REPORT ON FOUNDATION CONDITIONS

LITTLE CASTOR RIVER

## MEMORANDUM

Little Castor River Crossing  
Twp. Road Between Conc. 8 & 9  
At Lot 3, Russell Township

FIGURE 10

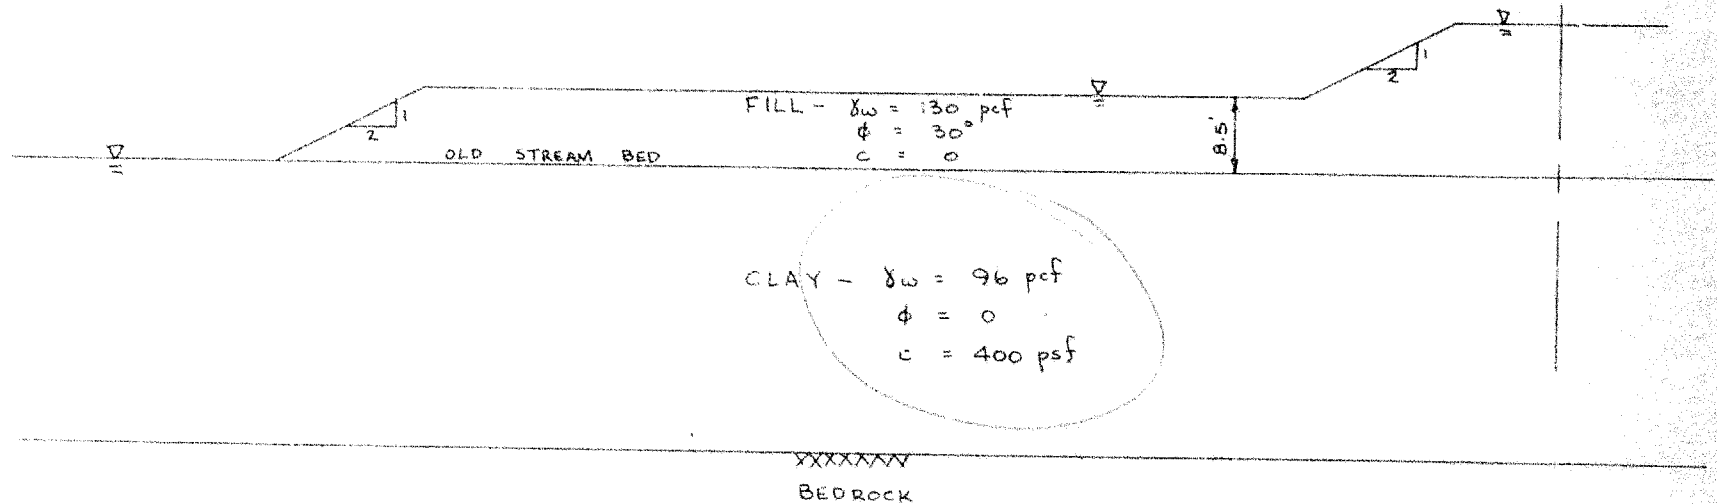
From this presentation it would appear that the twin culverts have a distinct advantage over the bridge. However, in his further presentation the Consultant points out that the factor of safety for the twin culverts scheme is only 1.05 as compared with 1.3 for the bridge scheme.

We feel that such a direct comparison is not fair and does not present the true picture.

It is our approach to aim for a factor of safety of about 1.2 to 1.3 when analyzing embankment stabilities. It does not matter whether there is a bridge or a culvert, because practically always, the possible failure is a failure in the sub-soil, and this would affect any structure.

It is suggested that the Consultant review his design in the light of the above mentioned.
